# PARTS & SERVICE NEWS

REF NO.	AA04080
DATE	June 8, 2004

**SUBJECT:** IMPROVED TORQUE CONVERTER STATOR SHAFT

**PURPOSE:** To introduce improved torque converter stator shaft

Fig. 1

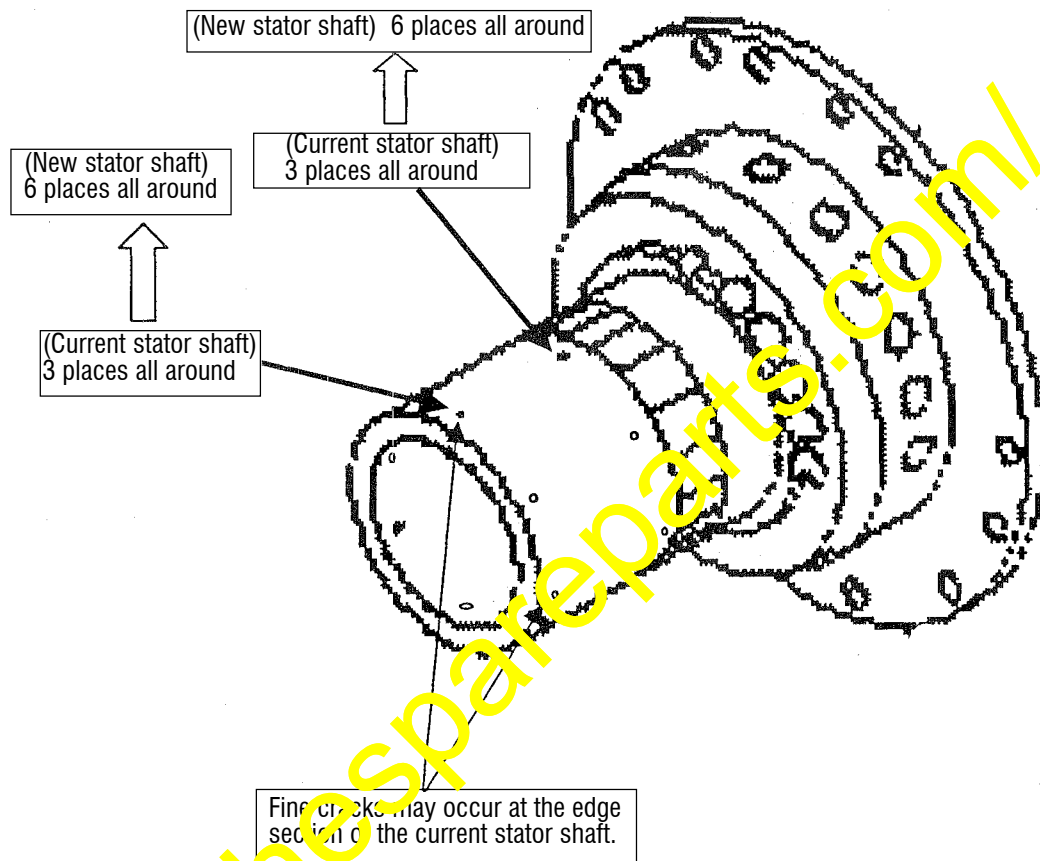
While overhauling work is being carried out, there were cases where fine cracks were found on the torque converter stator shaft by heat generation, which were unusable any more.

As Komatsu has developed a new torque converter stator shaft with improved lubrication characteristics, replace the torque converter stator shaft each time when fine cracks (refer to Fig. 1) are found on the torque converter stator shaft on these vehicles while overhauling them.

The number of the lubrication holes has been increased to double to increase the lubrication oil flow, thus improving the lubrication characteristics of the torque converter stator shaft.
